A RESOLUTION SPECIFYING FOLLOW-UP TO A PLANNING BOARD RECOMMENDATION TO MODIFY THE OPPOSITE SIDE STPEBACK PROVISIONS OF THE DOWNTOWN NEIGHBORHOOD PROTECTION OVERLAY ZONING DISTRICT REQUIREMENTS

Resolution No. 89/2006-07

DOWNTOWN NEIGHBORHOOD PROTECTION OVERLAY DISTRICT EXAMPLES OF DIMENSIONAL AND ARCHITECTURAL PROVISIONS

AN ORDINANCE AMENDING THE LAND USE ORDINANCE TO REVISE THE DOWNTOWN NEIGHBORHOOD PROTECTION OVERLAY DISTRICT OPPOSITE SIDE STEPBACK PROVISION

Figure 6.

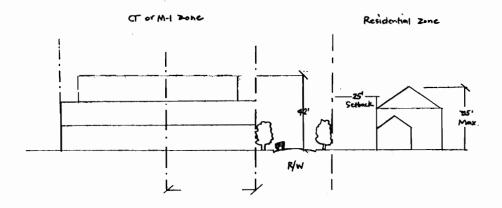
As was recommended on May 15, 2005 in relation to establishment of the Downtown Neighborhood Preservation Overlay zoning district, Paulsen moved and Reid seconded that the Planning Board recommend that the Board of Aldermen proceed with an amendment to the Land Use Ordinance to delete Section 15-185.1(d)(2)(b) and Section 15-185.1 (f)(2)(b).

- (2) A third story shall be permissible if:
 - a. All portions of such third story are set back at least ten feet from the second story façade of the building wall that faces a boundary line that abuts or is located directly across the street from residentially zoned property; and
 - b. The third story has a corresponding setback ("stepback") from the second story on the opposite side of the building (Figure 6).

Section 1. Article IX, Part 1, of the Carrboro Land Use Ordinance is amended by deleting subdivisions 15-185.1(d)(2)(b) and 15-185.1 (f)(2)(b).

Figure 9.

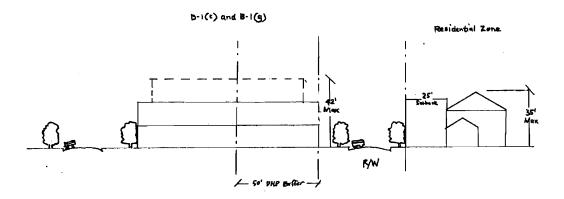
- (2) A third story shall be permissible if:
 - a. All portions of such third story are set back at least ten feet from the second story façade of the building wall that faces a boundary line that abuts or is located directly across the street from residentially zoned property; and
 - b. The third story has a corresponding setback ("stepback") from the second story on the opposite side of the building (Figure 9).
